Access Compliance Report

Public Rights-of-Way

Intersection ID: 7375	Main Street: TRYON_ST	Cross Street: TOM_HUNTER_RD	Location: NW
ADA ID: 7421E27FACF3	Ramp Type: Perp	Initial Pass/Fail: Fail	Overall Compliance: No
Severity Score: 1.25			
Codes/Mitigation Info/Possible Solution		Field Measurements/Component Compliance

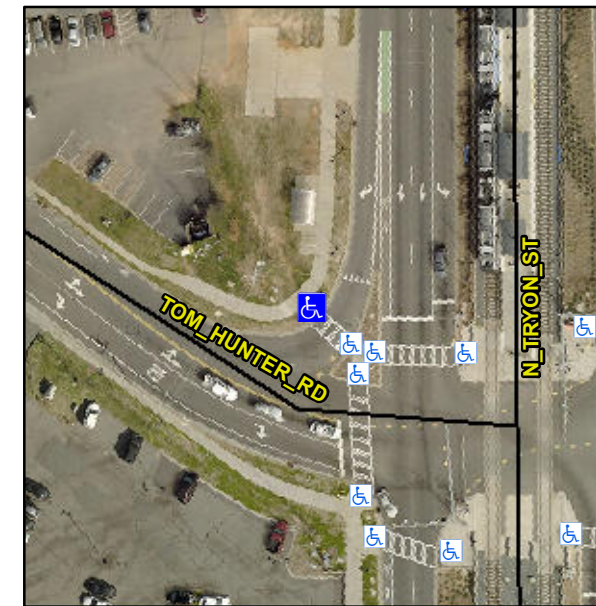
R304.5.3

Compliance	Description	Data	Compliance	Description	Data
N/A	Ramp Length (in)	94.0	Yes	Ramp Slope (%)	7.0
Yes	Ramp Width (in)	94.0	No	Ramp XSlope (%)	3.8
N/A	Flare Type LT	N/A	N/A	Flare Type RT	N/A
N/A	Flare Slope LT (%)	N/A	N/A	Flare Slope RT (%)	N/A
N/A	Flare Traversable LT?	N/A	N/A	Flare Traversable RT?	N/A
N/A	Landing Length (in)	N/A	N/A	DWS Provided?	N/A
N/A	Landing Width (in)	N/A	N/A	DWS Contrast?	N/A
N/A	Landing Slope (%)	N/A	N/A	DWS Length (in)	N/A
N/A	Landing X Slope (%)	N/A	N/A	DWS Full Width?	N/A
N/A	Landing Curb? (Y/N)	N/A	N/A	DWS Offset (in)	N/A
N/A	Shared Landing?	N/A			
N/A	Gutter Ponding?	N/A	N/A	Gutter Slope (%)	N/A
N/A	Gutter Lip Ht (in)	N/A	N/A	Gutter X Slope (%)	N/A
N/A	Painted X Walk1?	Yes	N/A	Painted X Walk2?	N/A
	X Walk 1 Direction	To SE		X Walk 2 Direction	N/A
N/A	X Walk 1 Width (in)	107.0	N/A	X Walk 2 Width (in)	N/A
	X Walk 1 Slope (%)	2.8		X Walk 2 Slope (%)	N/A
	X Walk 1 X Slope (%)	3.2		X Walk 2 X Slope (%)	N/A

Remove & Replace Entire Ramp.
